DESIGN REVIEW BOARD RECORD OF DECISION

Meeting Date August 22, 2024 **DRB Case No.** PDR-002779-2024

Address 652 Robin Glen Drive

DESIGN REVIEW STAFF REPORT – HILLSIDE SINGLE FAMILY

TITLE
Proposed Building
Elevations

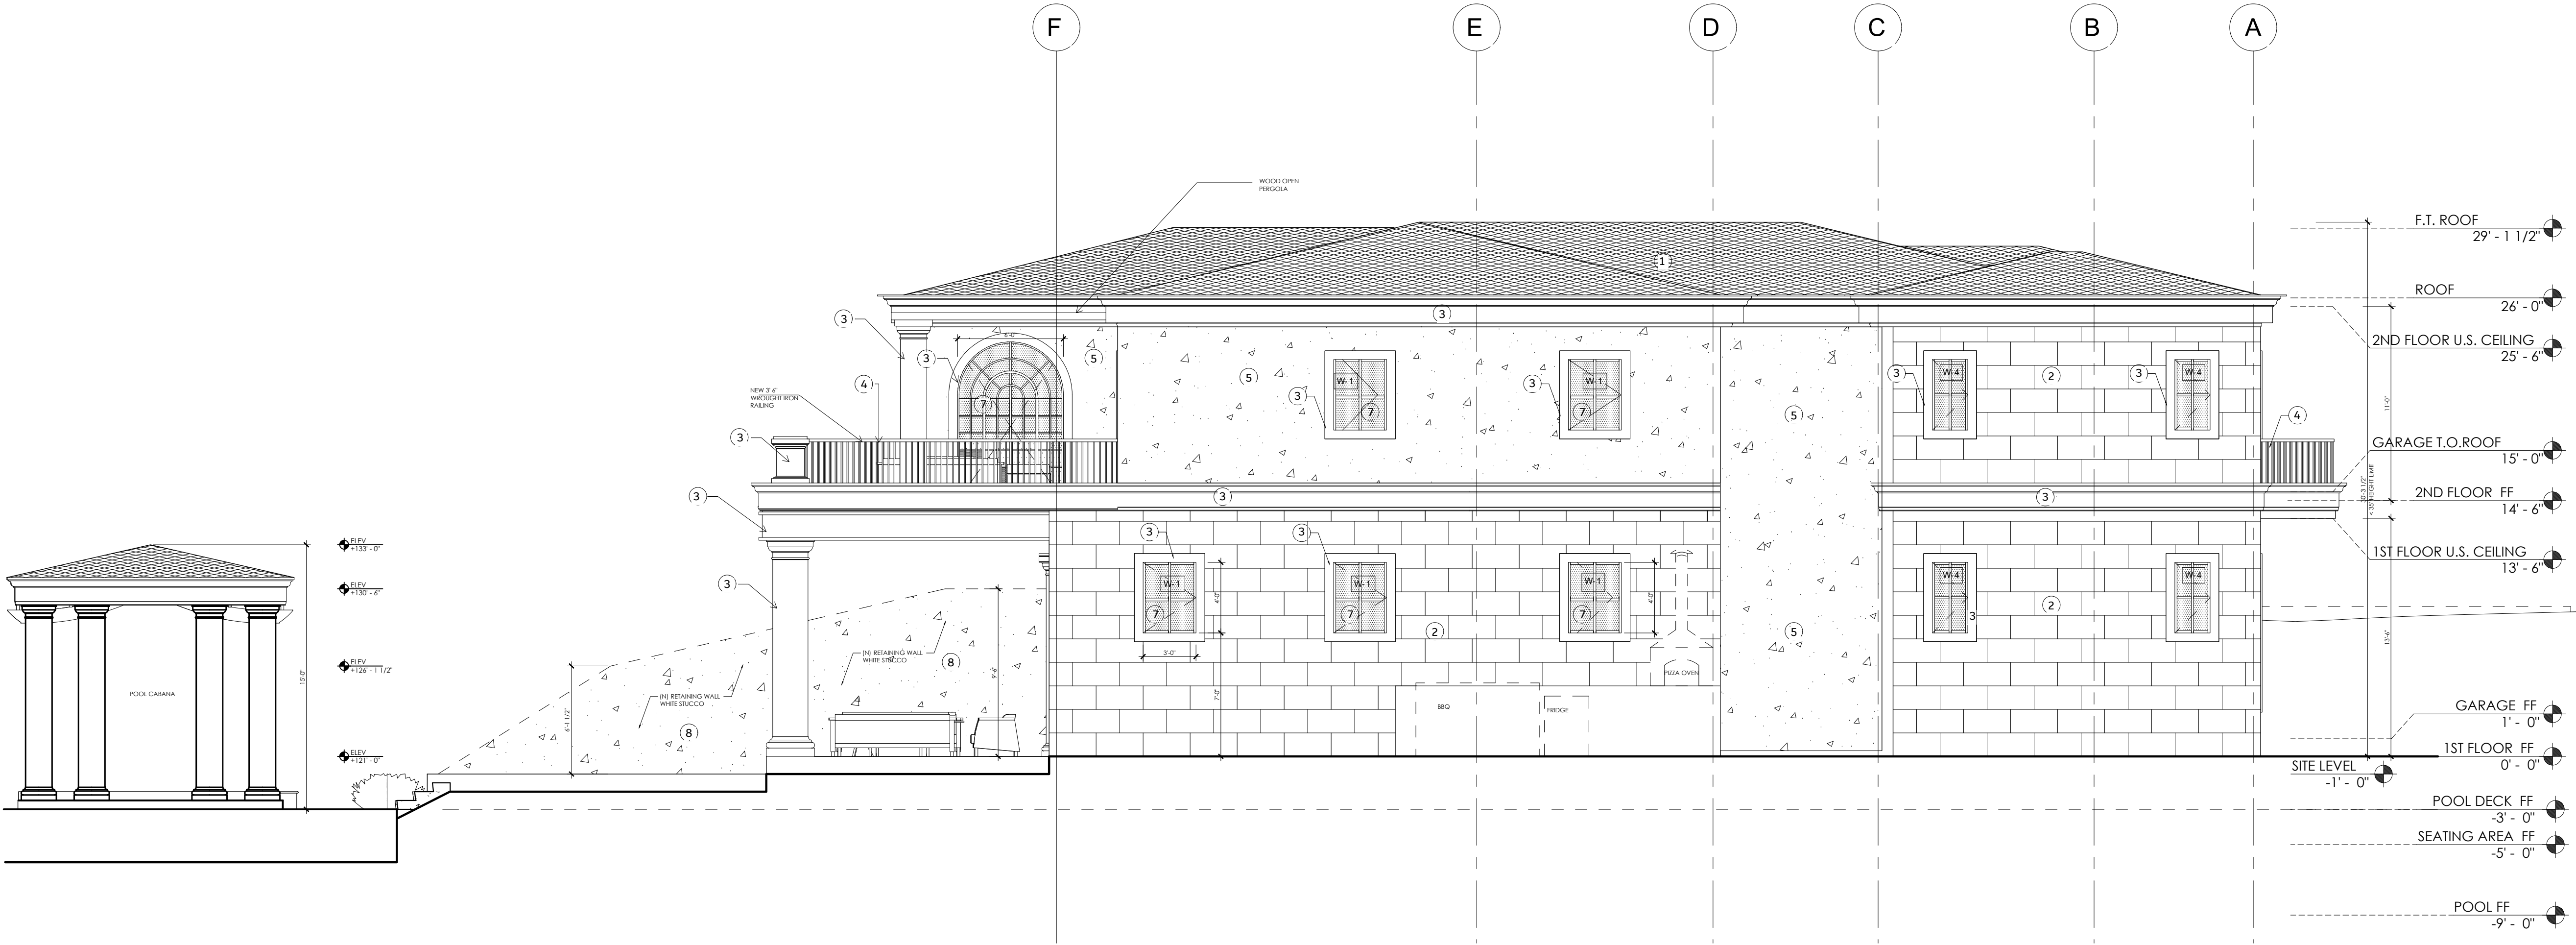
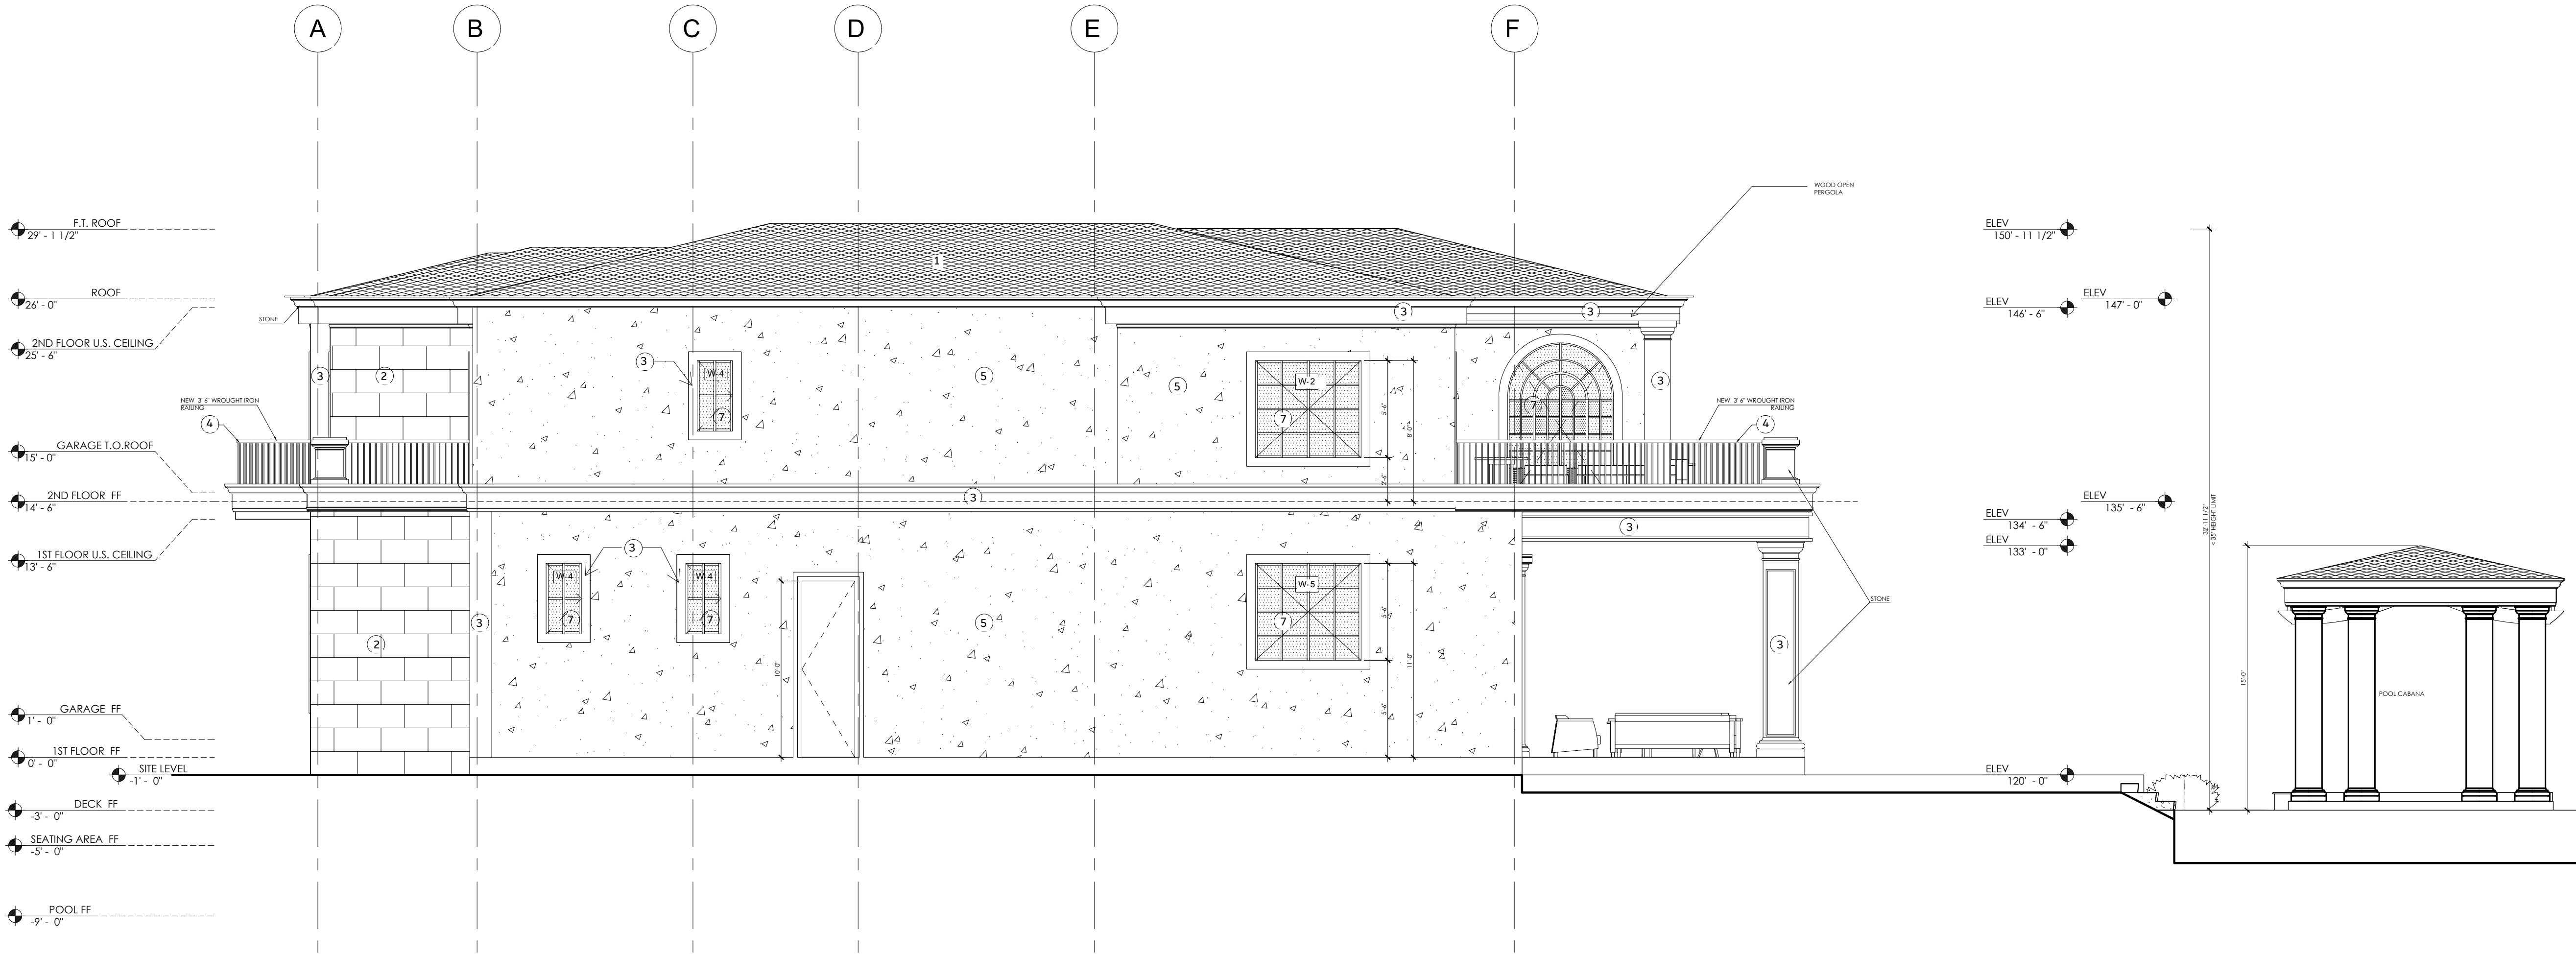
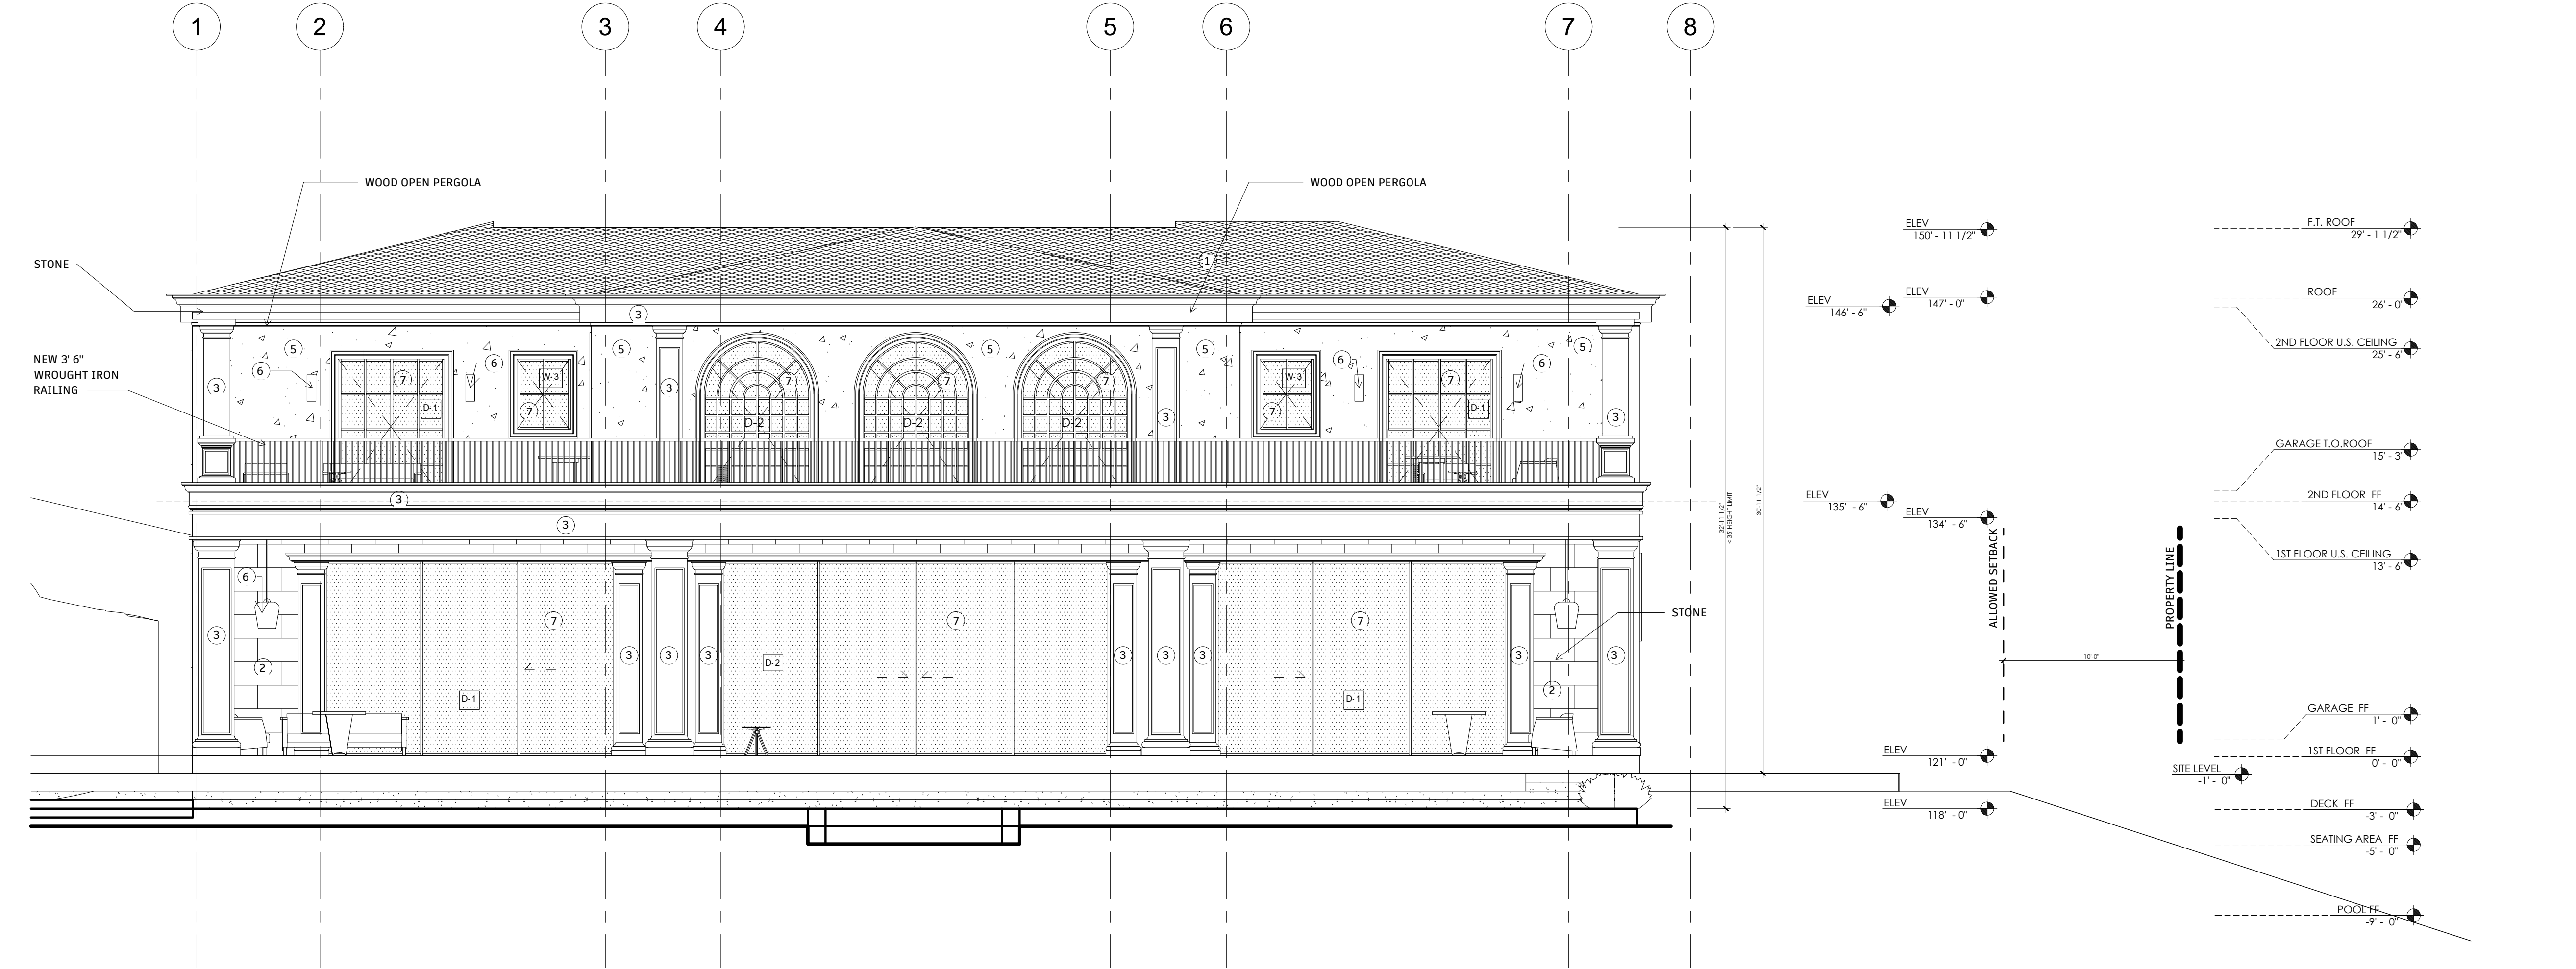
1. Reduce the proposed floor to ceiling height at the first and second floor; and lower the heights of the garage and pool cabana to provide better proportions and avoid the sense of monumentality as well as minimize the visual impact.
2. Redesign the facades that are visible from the street, particularly the east façade, to reduce the boxy appearance and monumentality of the house by stepping back the

second floor to follow the site topography, providing more articulations, using various roof heights and types, and incorporating a variation of materials/colors.

3. Revise the colors of the proposed exterior wall finishes to provide a distinct color palette.
4. Eliminate the balcony next to bedroom 5 (east side) to avoid potential privacy conflicts with the neighboring properties to the east.
5. Relocate the outdoor kitchen (BBQ counter) and HVAC condensers to the west side of the house.
6. Redesign the deck area and retaining walls on the west side to meet the zoning code height restriction.
7. Redesign the proposed retaining wall on the east side of the new house with the project's civil engineer to study the soil condition to avoid potential runoff.
8. Revise the landscape plan to replace the proposed shrubs on the east side of the house with drought-tolerant hedges or trees that will grow tall to provide privacy buffer.
9. Revise the proposed material for the windows to meet Building and Safety code (Title 24) requirements.
